**PROJECT:** North Hancock Road Extension Phase IIIA and IIIB  
**LAKE COUNTY PROJECT NO.:** 2014-11  
**FPN:** 435515-1-58-01  
**CONTRACTOR:** Pospiech Contracting, Inc.  
**SUBJECT:** School Update Meeting  
**DATE:** September 23, 2015  
**FILE:** 2.3 (09-24-2015\_School\_Update\_Meeting)  
**START:** 10:00 AM **END:** 10:45 AM

**NAME OF PROJECT:** North Hancock Road Extension Phase IIIA and IIIB  
**FINANCIAL PROJECT ID:** 435515-1-58-01  
**LAKE COUNTY PROJECT NUMBER:** 2014-11  
**NAME OF CONTRACTOR:** Posploch Contracting, Inc.  
**SUBJECT:** RFP-12  
**DATE:** September 29, 2015  
**FILE NO.:** 6.2 (09-29-2015\_RFP-12)

**NAME OF PROJECT:** North Hancock Road Extension Phase IIIA and IIIB  
**FINANCIAL PROJECT ID:** 435515-1-58-01  
**LAKE COUNTY PROJECT NUMBER:** 2014-11  
**NAME OF CONTRACTOR:** Pospiech Contracting, Inc.  
**SUBJECT:** RFP-13  
**DATE:** October 2, 2015  
**FILE NO.:** 6.2 (10-02-2015\_RFP-13)

**3 WAY STOP HANCOCK / BRIDGER  
TEMP SIDEWALK CONNECTION  
PERM SIDEWALK CONNECTION**

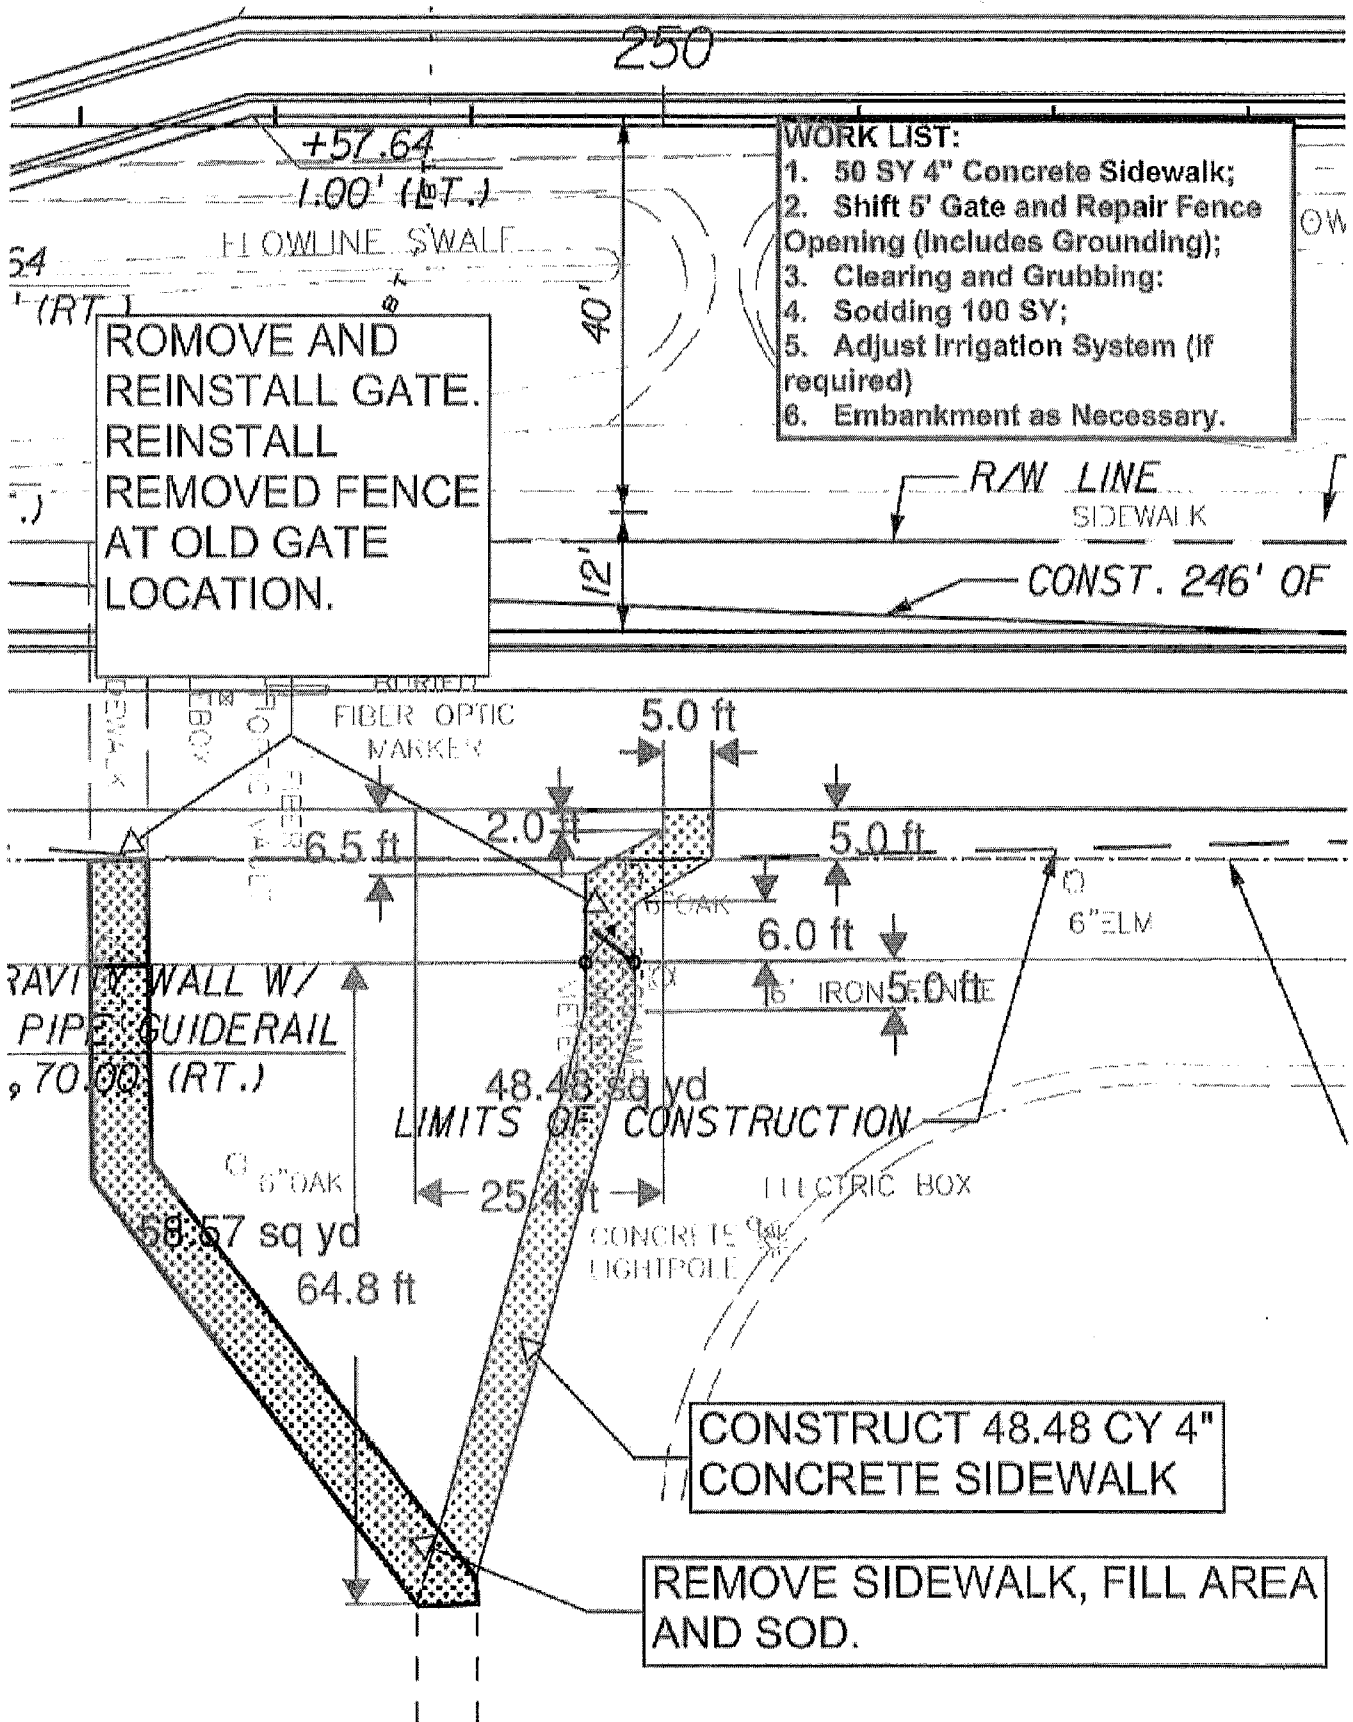
1. PHASE 2 CONSTRUCTION, PROVIDE THREE WAY STOP AT THE INTERSECTION OF N. HANCOCK ROAD AND BRIDGER TRAIL COURT.
2. PHASE 2 CONSTRUCTION, PROVIDE TEMPORARY SIDEWALK AND PEDESTRIAN CROSSING OF N HANCOCK STA 231+80+1/4.
3. PROVIDE PERMANENT SIDEWALK CONNECTION FROM THE EXISTING SOUTH SIDEWALK ALONG OLD BRIDGER TRAIL COURT TO NEW SIDEWALK STA 231+70+1/4, LEFT.
4. PROVIDE PERMANENT SIDEWALK CONNECTION FROM THE EXISTING SOUTH SIDEWALK ALONG OLD BRIDGER TRAIL COURT AROUND THE NEW TURKEY FARM ROAD CUL-DE-SAC (5' WIDTH) CONNECTING TO EXISTING TURKEY FARM ROAD SIDEWALK.

**PERMANENT SIDEWALK CONNECTION 125 SY EST**

# FOX TRAIL AVE PHASE 2 DETOUR PLAN

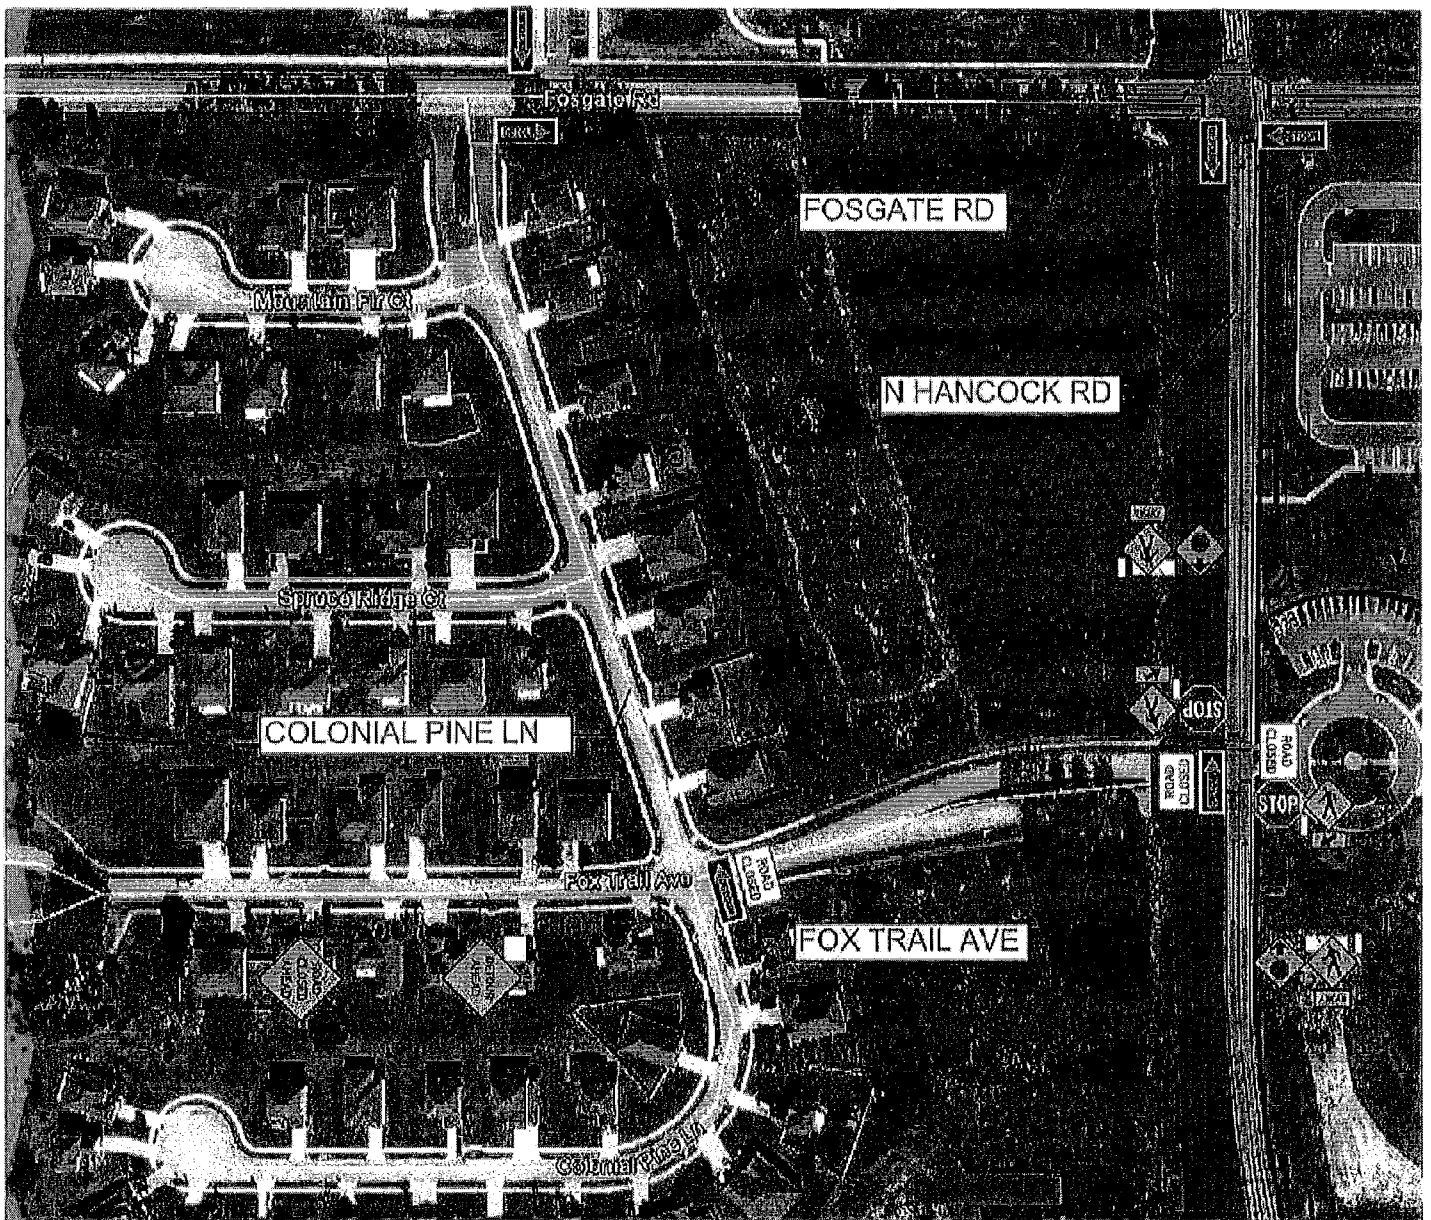
15. Possible Closure of Fox Trail Ave during Phase 2 construction. School representatives had no objection to proposed Fox Trail Ave closure / detour. School requested that access to main school entrance also be maintained in closed configuration during Phase 2 construction. Tierra to revise plan and provide copy with meeting minutes;

# STA 250+00, RIGHT PEDESTRIAN ACCESS

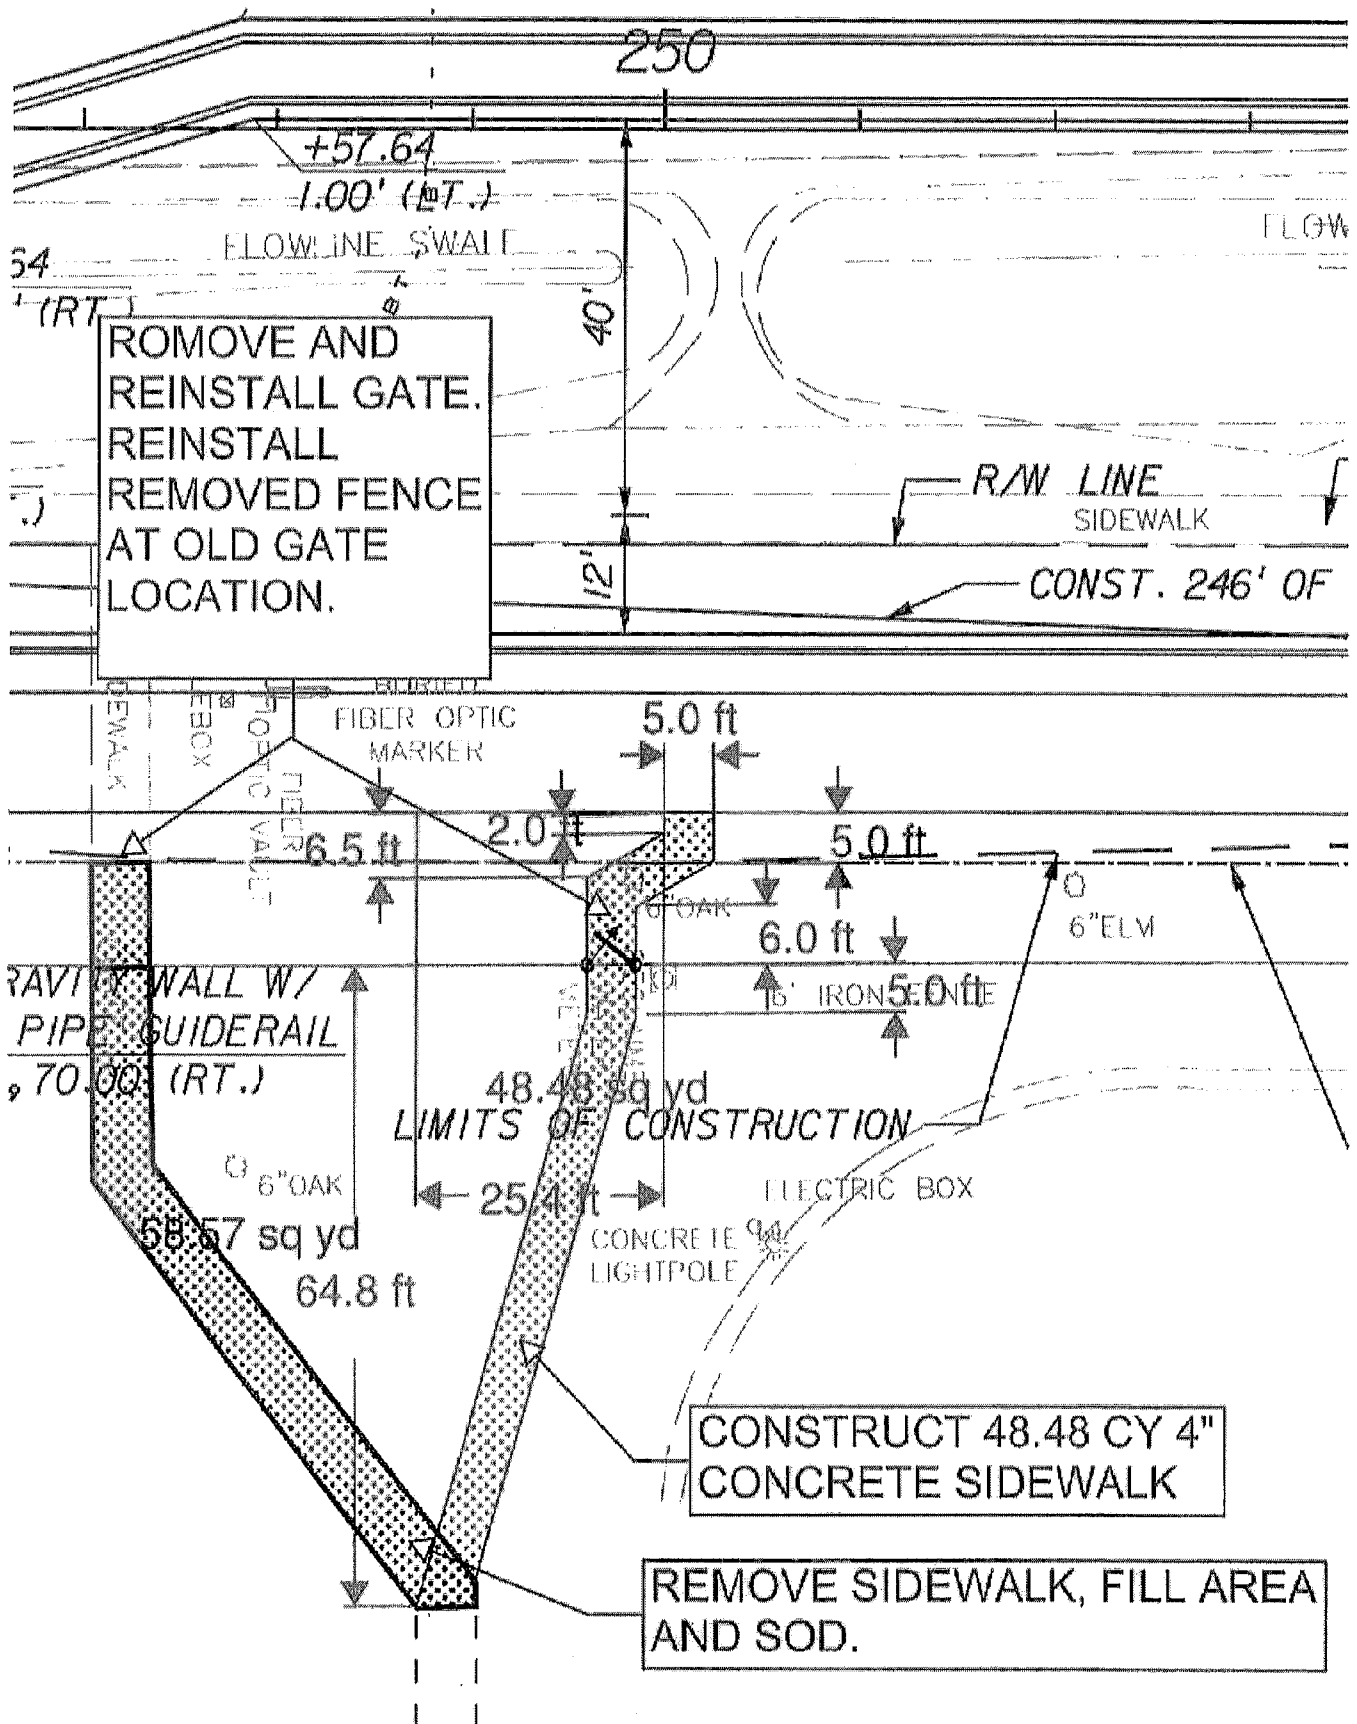
Find attached sketch for RFP-12 showing construction of Pedestrian Access to school at STA 250+/-, RT.

Provide cost and time proposal for this requested additional Work. Be reminded that existing unit cost items must be employed when available.

# RFP-13, ADDED COST ITEMS DETAIL

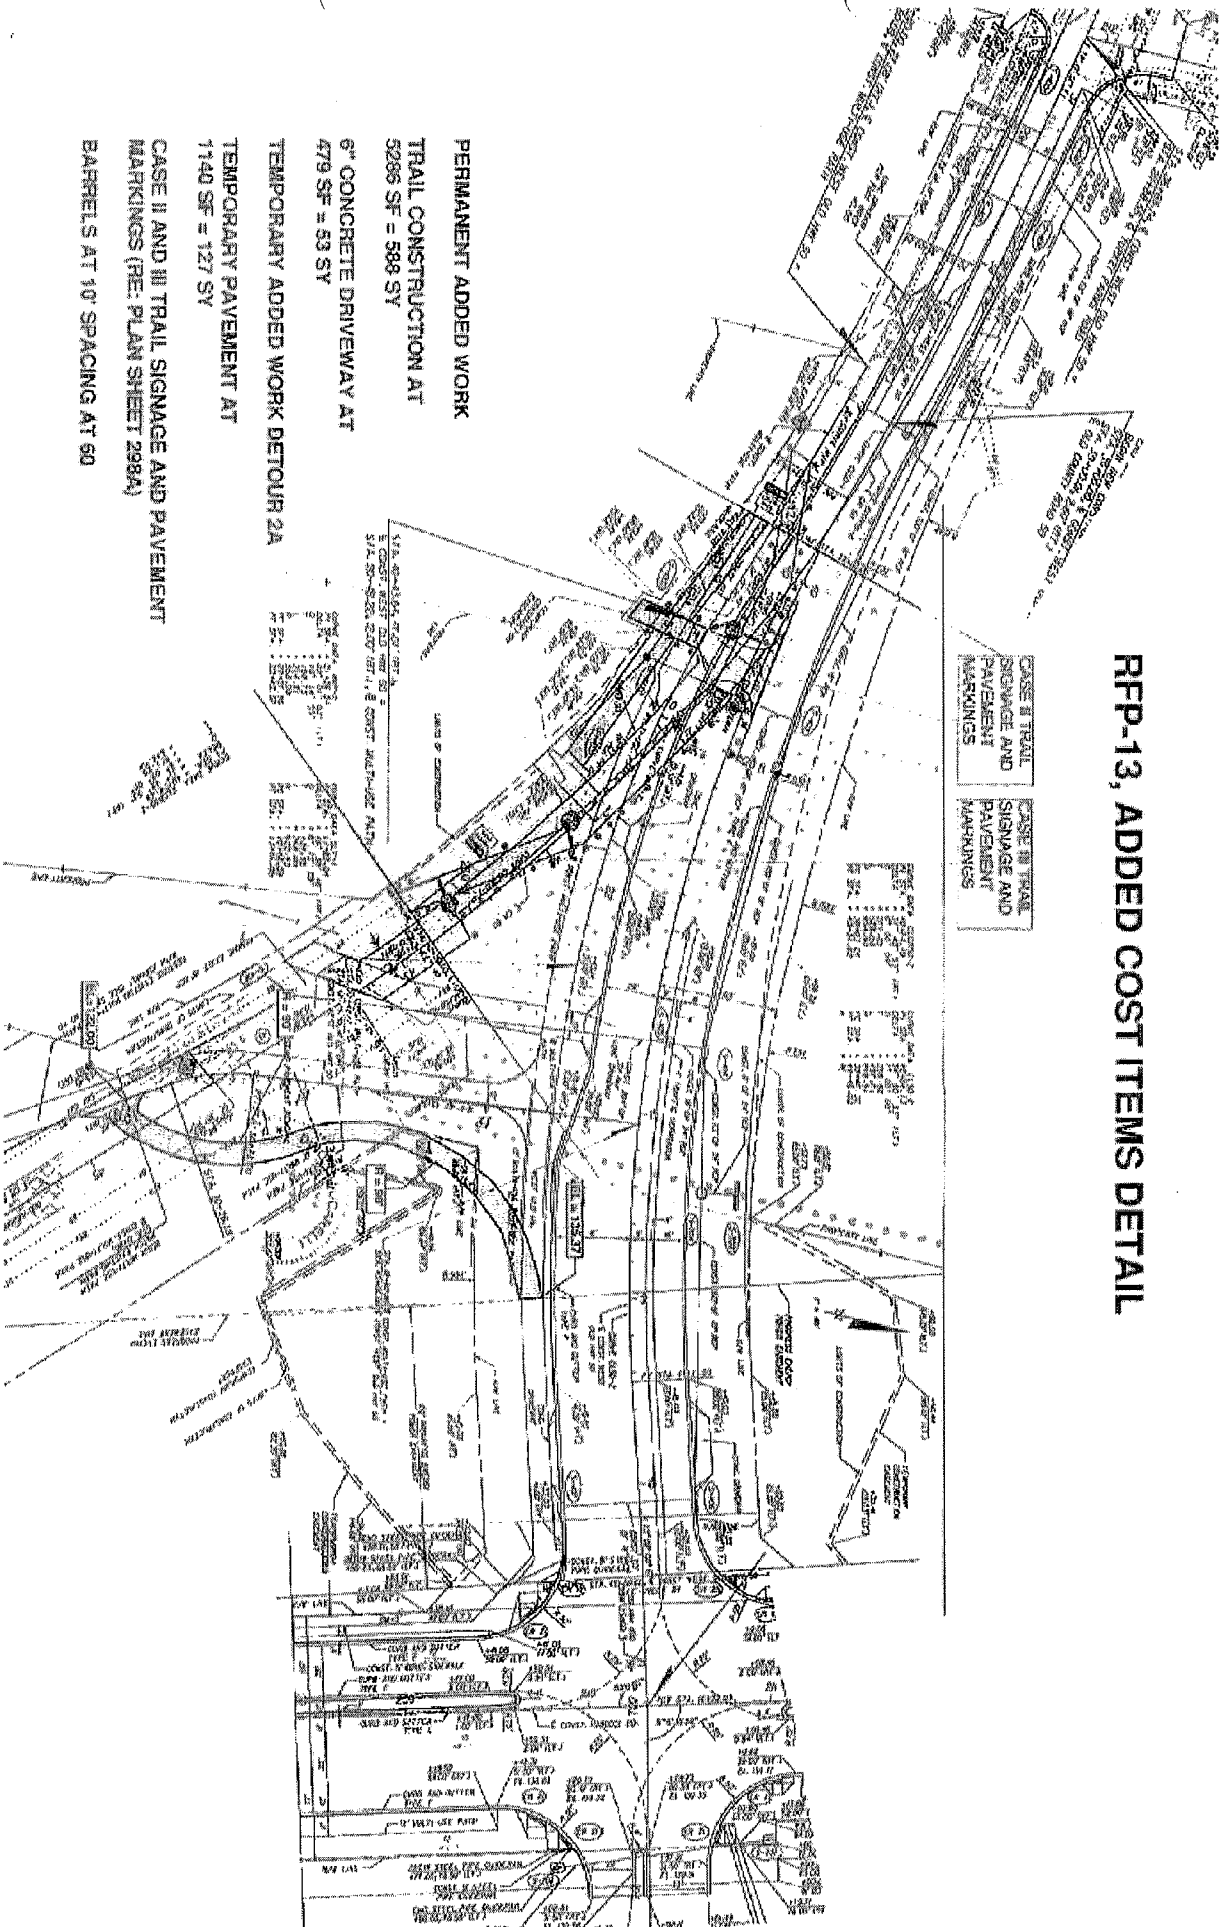
Find attached details for RFP-13 showing modifications related to the trail along Old 50 West. In general as much of the existing trail as possible is to remain in place. New MOT Phase 2A is added to provide temporary trail and temporary driveway access through the area.

PERMANENT ADDED WORK

TRAIL CONSTRUCTION AT

5286 SF = 588 SY

6" CONCRETE DRIVEWAY AT

479 SF = 53 SY
